CONVERT SHIM to CAMPY
NEW F482SB-11S to F582SB

Date: 15.March 2013
By Milan Krušinský

CONVERT SHIM to CAMPY NEW F482SB-11S to F582SB

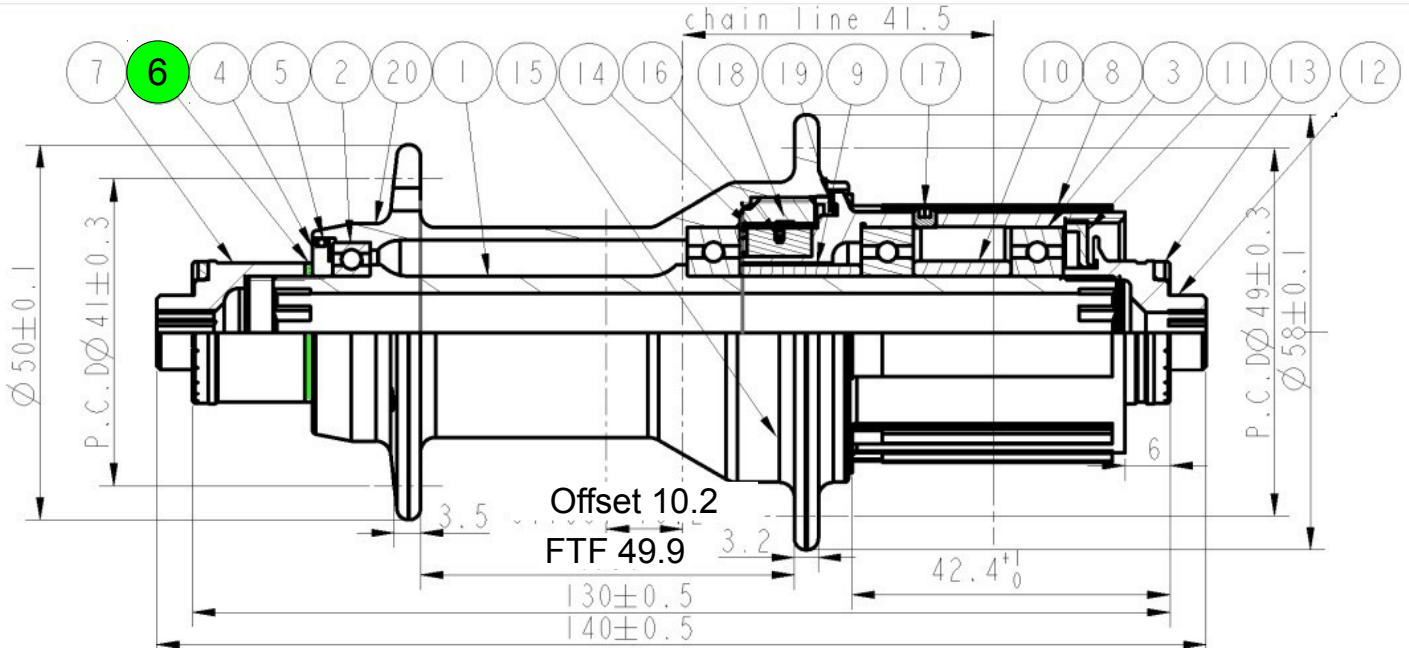
This hub is using EASY 3in1 system, what means that there are no need to interchange any other parts except Cassette Body, but there is needed to Relocate Washer (marked in Green).
